Construction Division
Additions & Alteration Charges Approval Form

Details of Additions & Alterations

Flat No	408	Block no.	' D '
Flat Area	1660 sft	Type	Deluxe / Luxury
Buyer Name	Kiran Kumar K		
Phone No.		Email

Modification proposed in D-408, Gulmohar Residency

Changes in kitchen platform: (mark on plan)

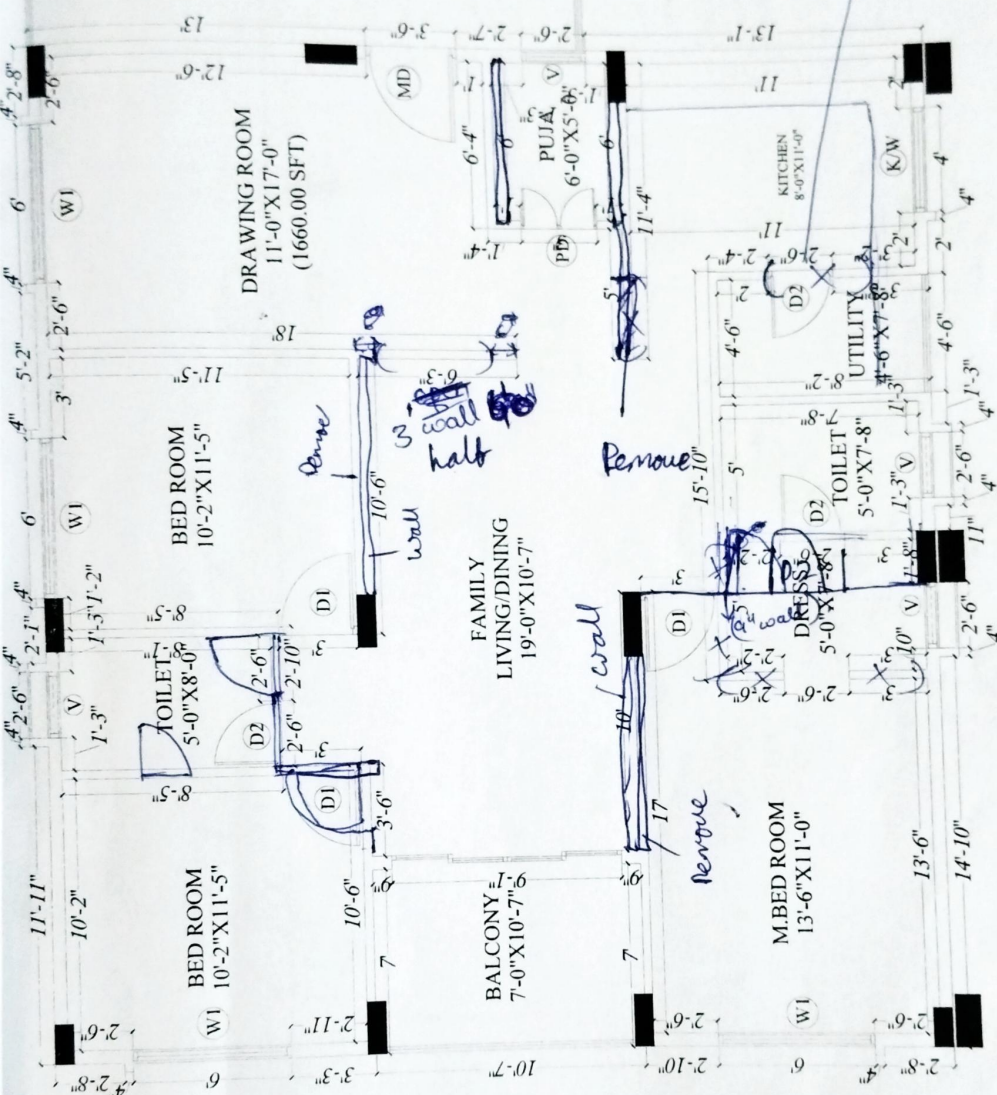
① place Cement Plat form & granite

WORKING PLAN-1660 Sft-B1 TYPE	Description	Direction N 	Owners & Developers :	Date :	25.09.2020	Promoted by
			Modi Reality Mallapur LLP	Prepared By :	Jayapradha	Modi Properties Pvt Ltd
			Project Name & Phase :	Approved By :	Soham Modi	
			Gulmohar Residency	Scale :	N T S	Phone : +91-40-66335551

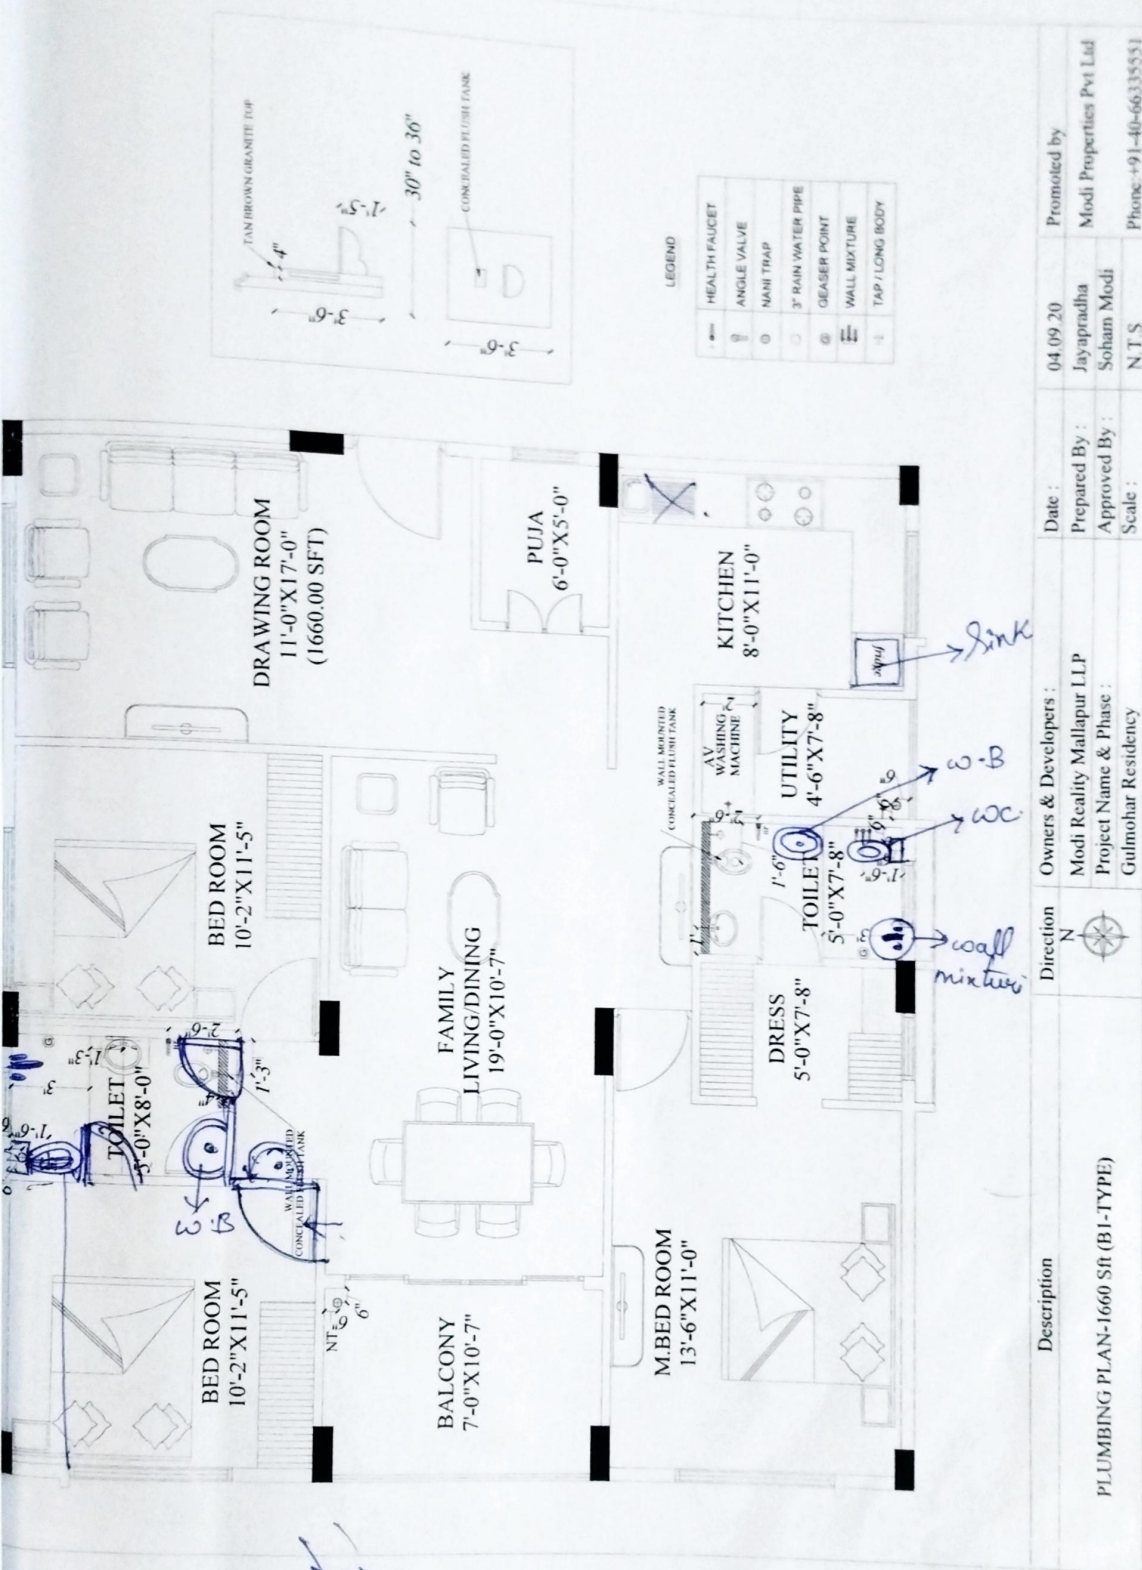
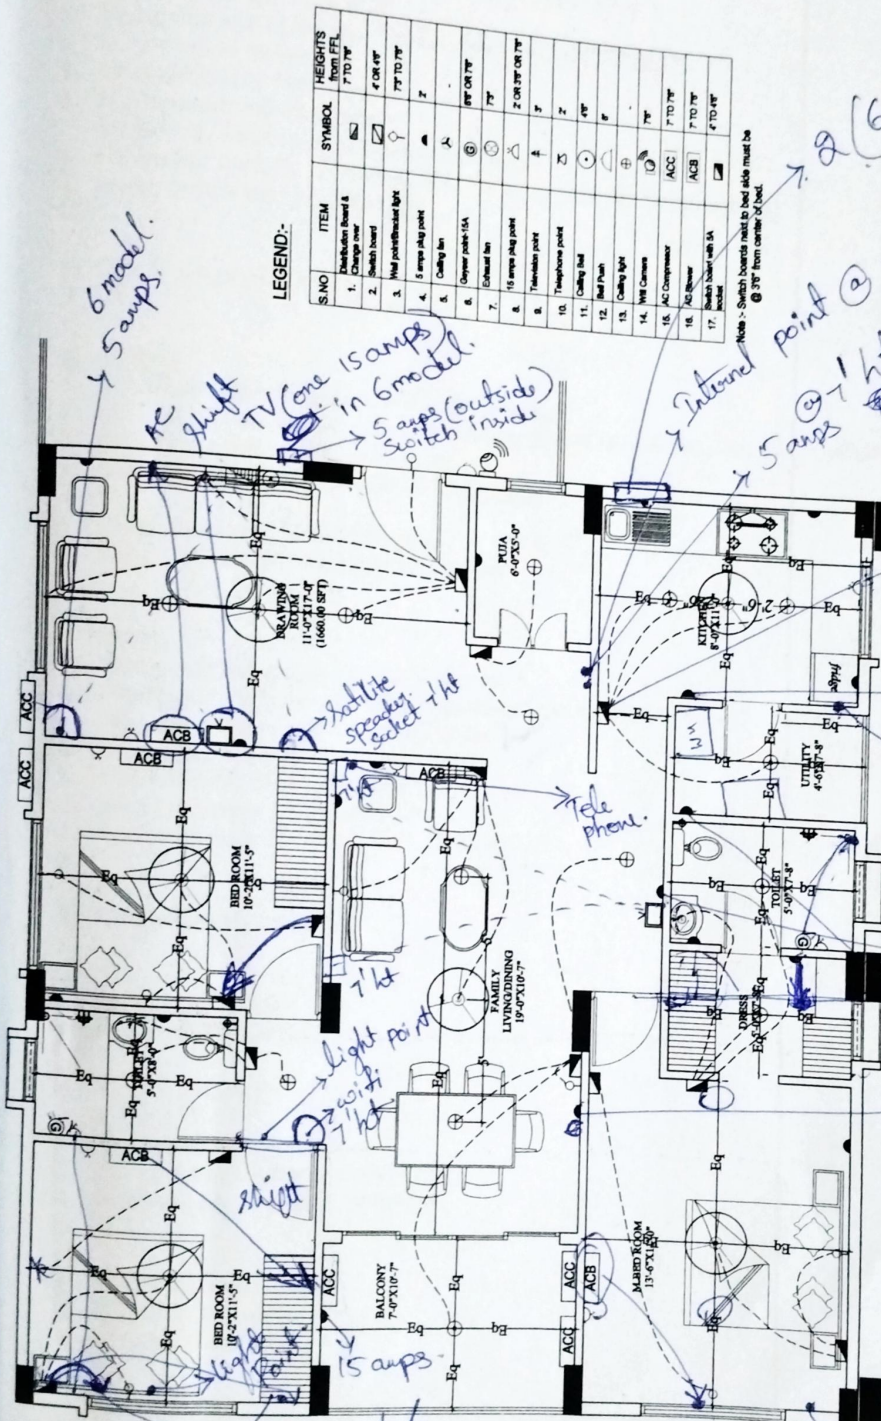
① changes to be done as per plan

① changes to be done as per plumbing plan

① Washing machine step not required.
